**HORIZONTAL DIRECTIONAL DRILL ANALYSIS  
SUSQUEHANNA RIVER CROSSING  
PADEP SECTION 105 PERMIT NOS.: E67-920 and E22-619  
PA-YO-0063.0000-RR-16  
(SPLP HDD No. S2-0280)**

This reevaluation of the horizontal directional drill (HDD) installation of a 16-inch diameter pipeline that traverses under the Susquehanna River has been completed in accordance with Stipulated Order issued under Environmental Hearing Board Docket No. 2017-009-L (Order). During drilling of the first HDD and installation of the 20-inch diameter pipeline, an inadvertent return (IR) was identified during the pilot phase intersect from the East HDD unit; therefore, the second HDD requires reevaluation in accordance with the Order. The first HDD and 20-inch pipeline installation was initiated before the issuance of the Order.

### **REDESIGNED HORIZONTAL DIRECTIONAL DRILL DESIGN SUMMARY: 16-INCH**

Figure 1. Original 16-Inch HDD Plan and Profile

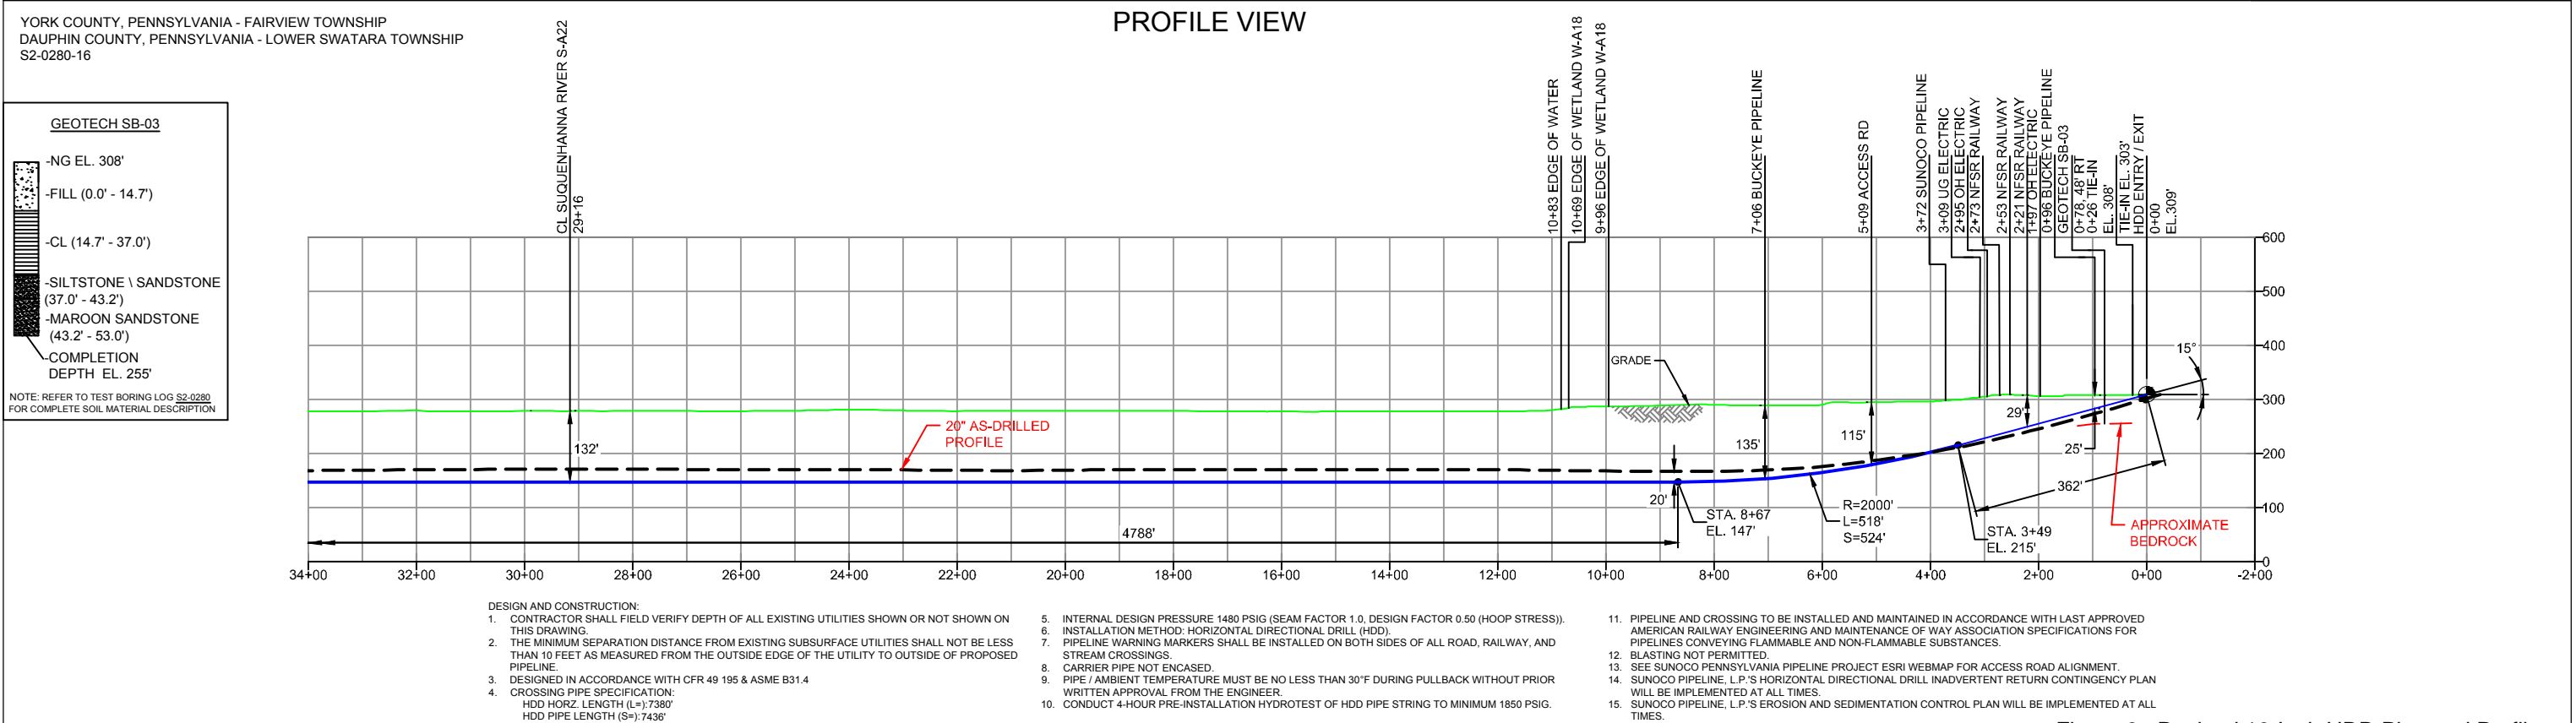
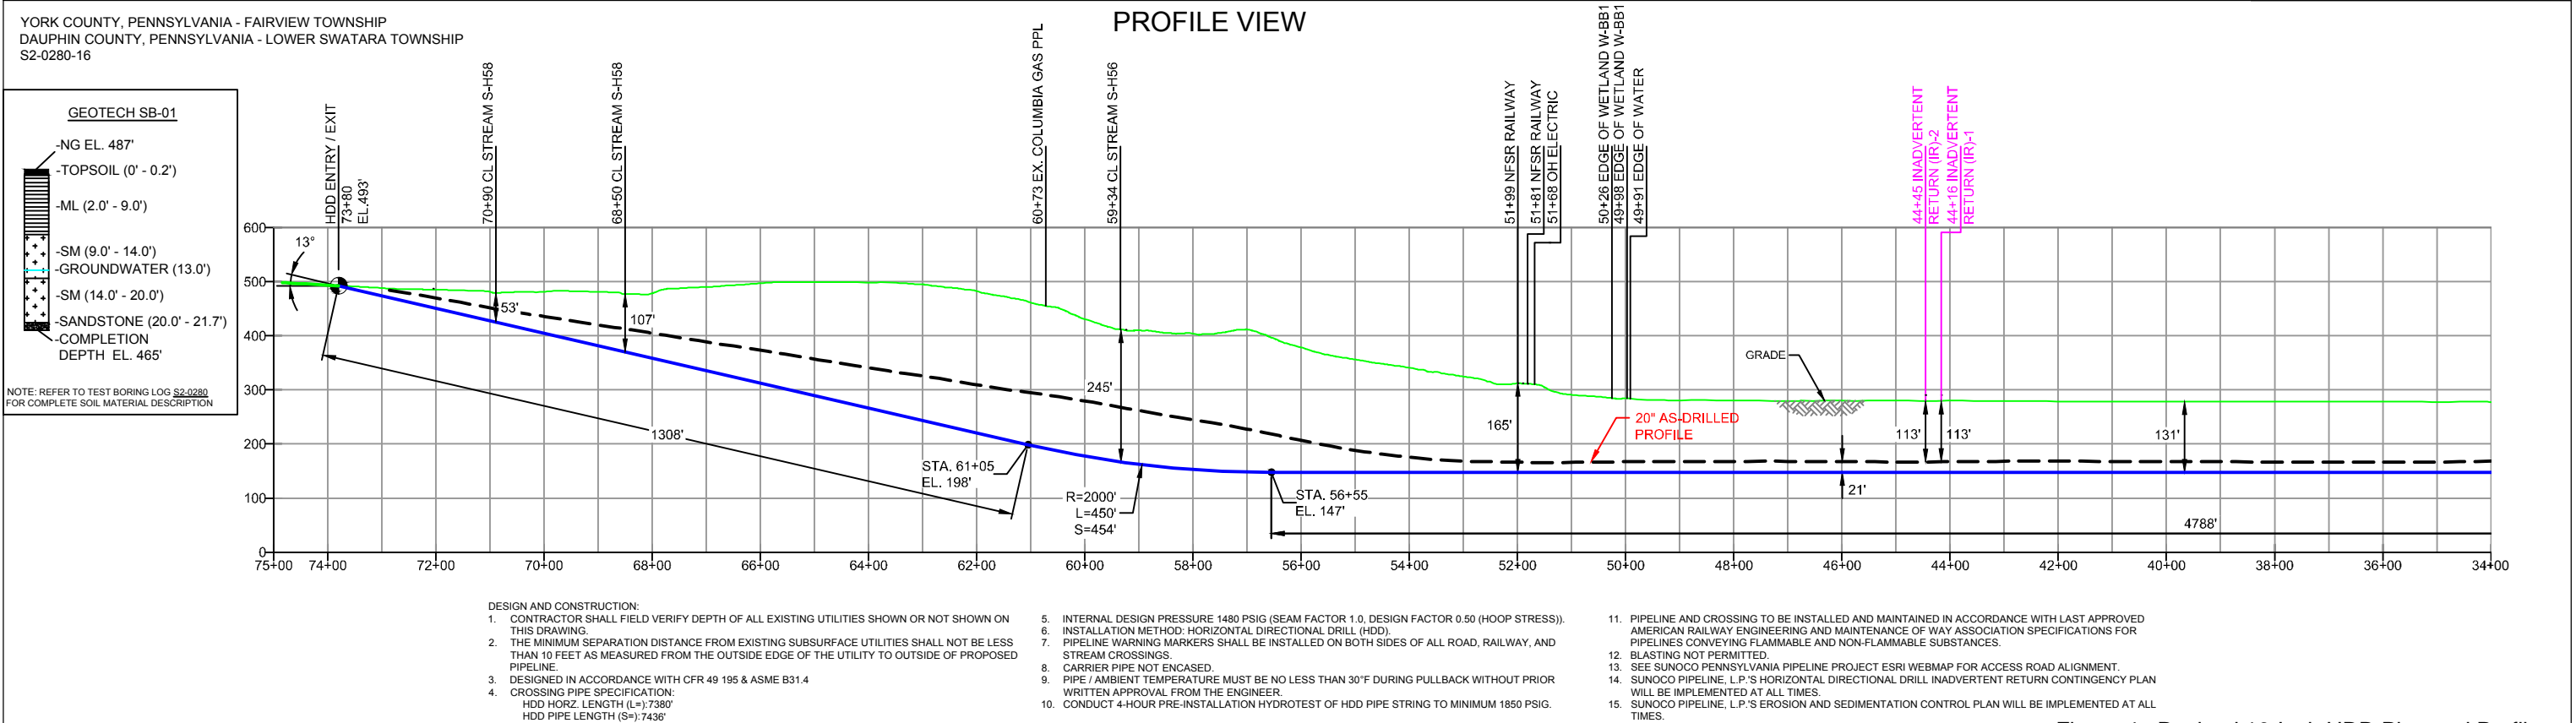
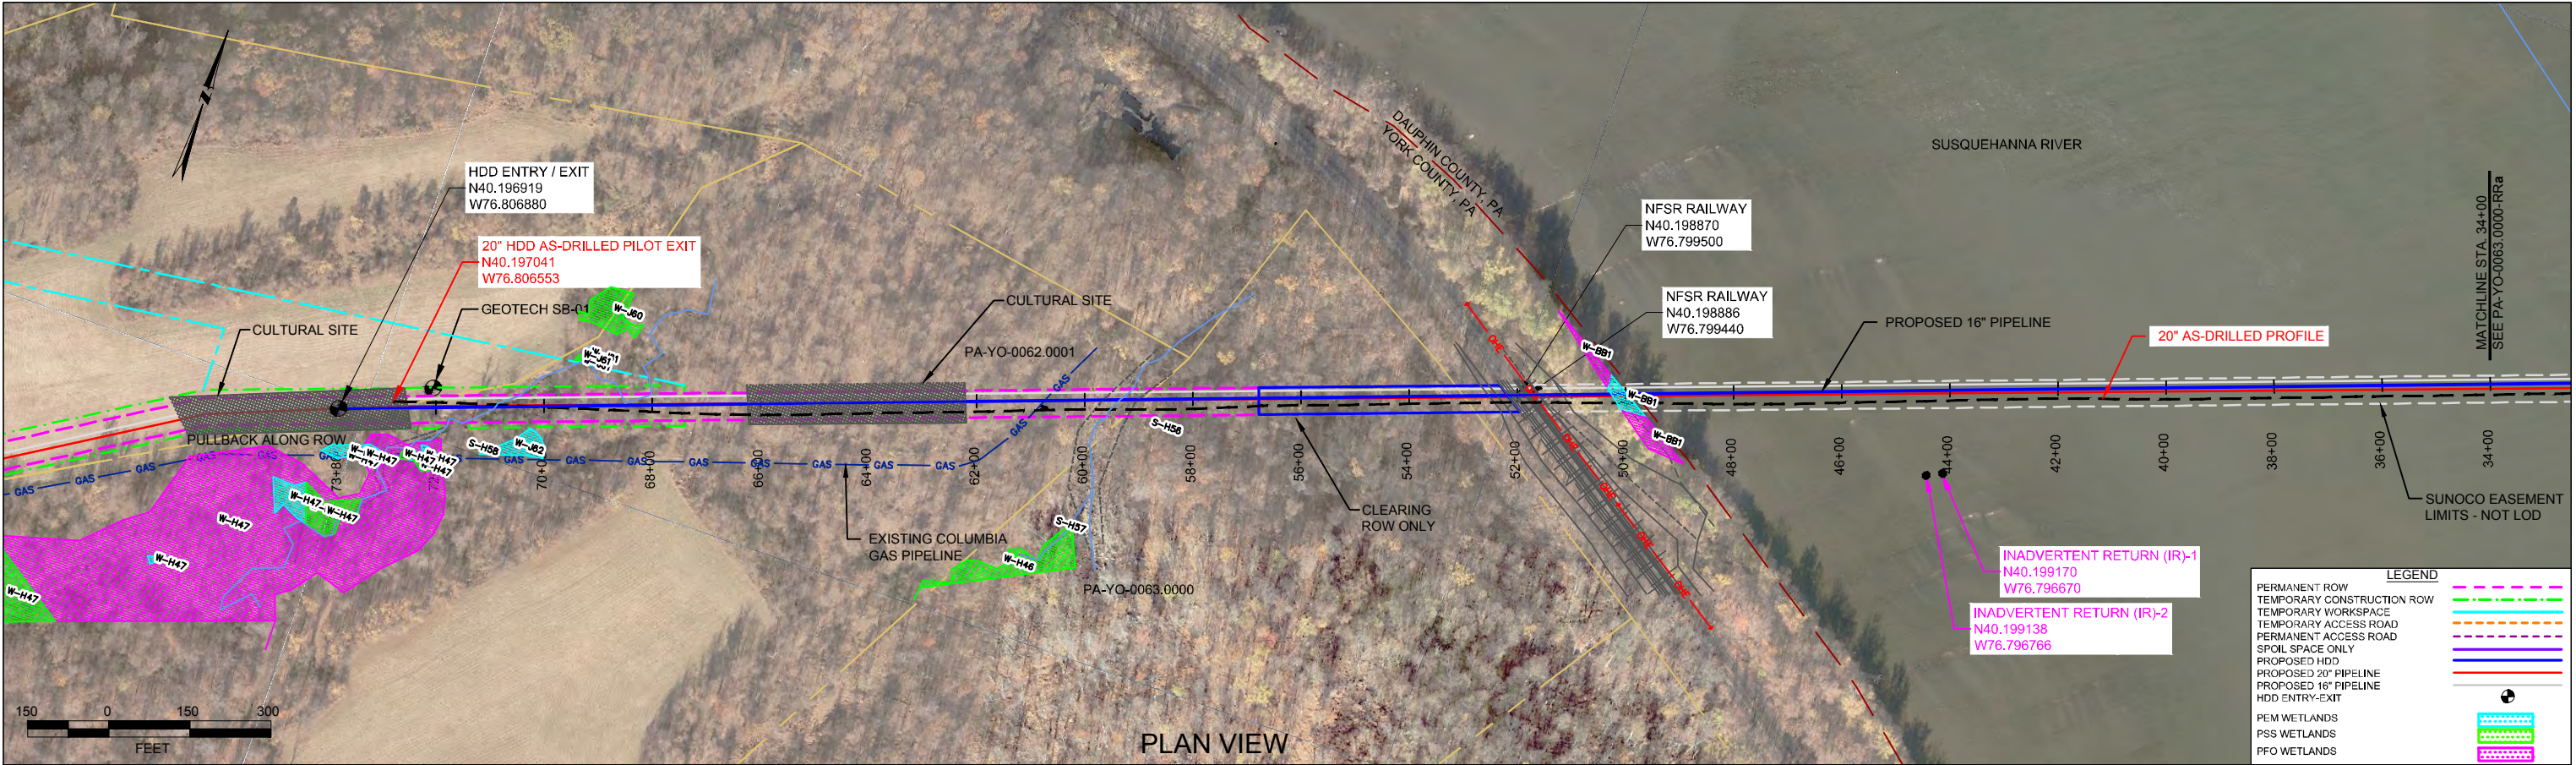
- Horizontal length: 7,380 ft.
- Entry/Exit angle: 13-15 degrees
- Maximum Depth of cover: 245 ft.
- Depth below Susquehanna River: 113-131 ft.
- Pipe design radius: 2,000 ft.

The 16-inch HDD profile has been re-designed to allow for a deeper crossing beneath the Susquehanna River than was completed for the 20-inch pipeline installation. The inclination of the entry and exit angles has been increased in order to install the 16-inch pipe through protective soils, residual soils, and bedrock in closer proximity to the entry and exit points than the original, shorter and shallower profile. From a geologic

It is SPLP’s intent to modify the original profile design and to pursue a deeper and longer HDD profile. Figures 1 and 2 in Attachment 2 presents the original permitted HDD plan and profile. Figures 3 and 4 present the revised HDD plan and profile.

perspective, the longer and deeper profile, in conjunction with the proposed engineering controls and/or drilling best management practices, will be used to reduce the risk of an IR.
